Proposal to amend ECE/TRANS/WP.29/GRSG/2022/7

Submitted by the experts of Spain

Figure 1

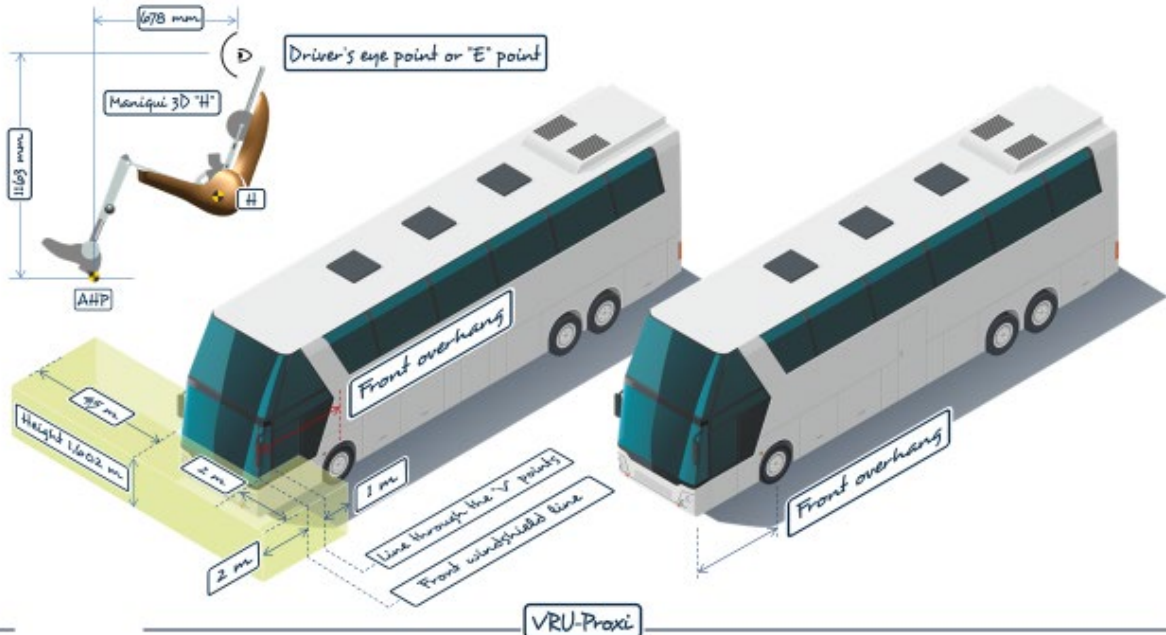
It is considered that the testing procedure is independent of the distance between the front axle and the foremost point of the vehicle. The reference point is the AHP (See explanatory figures 1 to 3)

Delete Paragraph 2.2 (c):

- “5.3. ~~(e) The distance in the X axis between the centre of the front axle of the vehicle and the foremost point of the vehicle;”~~
